HISTORIC DISTRICT REVIEW BOARD MEETING AGENDA

Title: HDRB #23-001; Demolition; 725 Elden Street

Staff Contact: Tamsin Himes
Lead Planner – Development and Design
tamsin.himes@herndon-va.gov
(571) 612-0537

Staff Contact: Tamsin Himes
Lead Planner – Development and Design
tamsin.himes@herndon-va.gov
(571) 612-0537

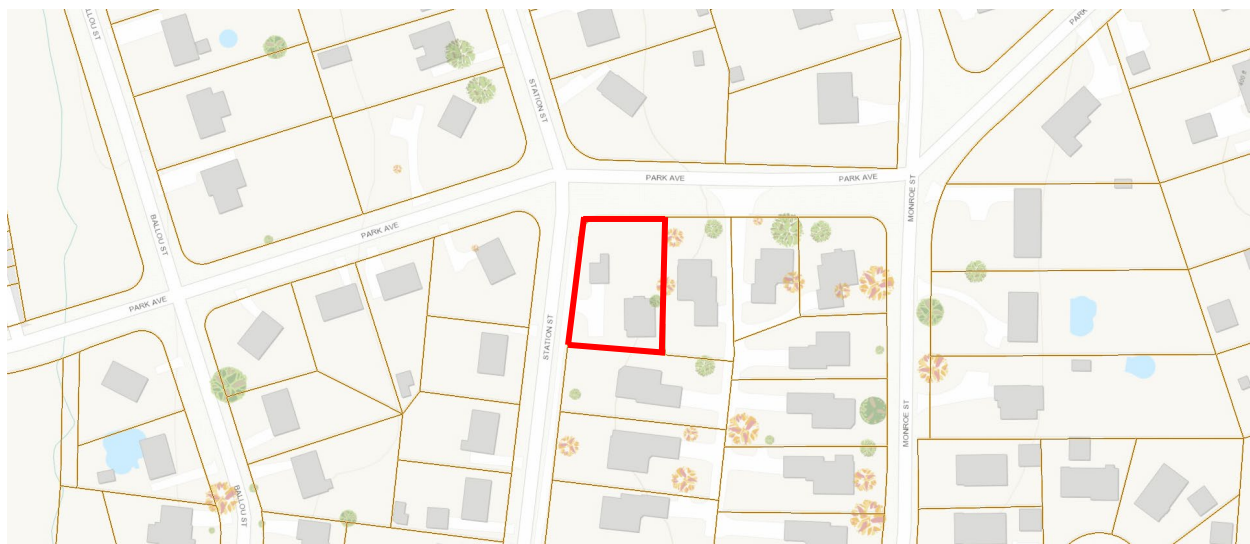
This application proposes replacing all remaining wood windows (23 in total) and two non-wood windows with new vinyl windows. The structure contains seven newer windows that are currently vinyl which are situated on the addition or newer portions of the house. The existing vinyl windows are not proposed to be replaced. The applicant stated that the proposed replacement windows would not alter the size of the window openings created by the removal of the original wood windows but did not provide specifics regarding the size, light division, or specific design of the proposed windows. The proposed replacement windows are Window World double-hung vinyl windows.

The modifications proposed for this case have already been completed. All wood windows have been replaced with vinyl windows. This application seeks a Certificate of Appropriateness for an unapproved existing condition.

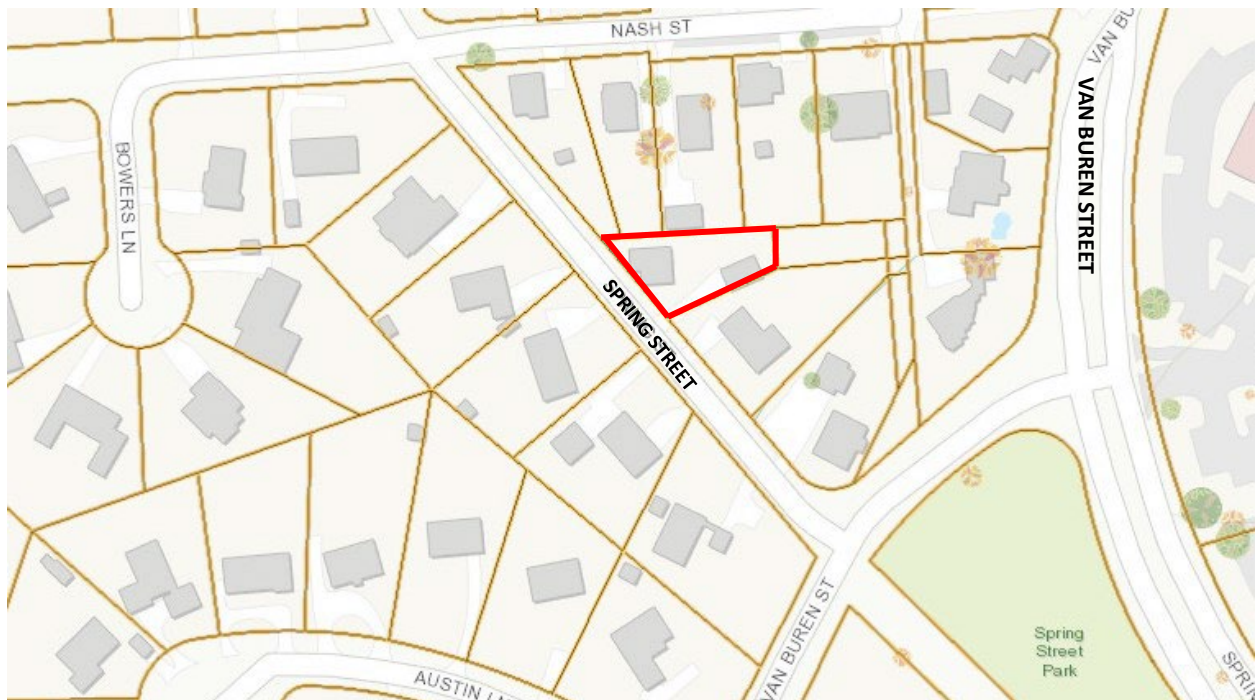
This application proposes to replace the existing openings (one exterior door and one set of double windows) in a historic porch on the side elevation. The new door will be 36" wide (4" wider than the existing door) and shifted 12" to the right from its existing location. The set of windows will be reduced to a single double-hung window with a new alignment on the wall. The new door will be fiberglass (Provia Heritage Smooth Entry Door), designed with a half lite with two vertical panels on the bottom half. The window will be aluminum clad wood double hung (Pella Lifestyle) with a two-over-two, simulated divided light grilles.

window schedule and location detail should be submitted to staff for this determination to be made. This staff report addresses only the door and two windows on the south façade facing Spring Street.

As referenced below, the Guidelines emphasize the importance of retaining solid-to-void ratios on building facades. The guidelines also express the importance of retaining character defining features such as porches. Though the enclosure of this porch predates the Historic District creation, it’s current design retains the porch context with the high degree of glazing. The proposed changes appear to notably change the solid-to-void ratio and remove recognition of this feature as a enclosed porch. It is important to maintain the context of this portion of the structure as a porch.

- Window schedule and location detail. Photos of each elevation annotated to indicate which windows are being replaced along with an aerial image or property survey calling out the location of the windows.
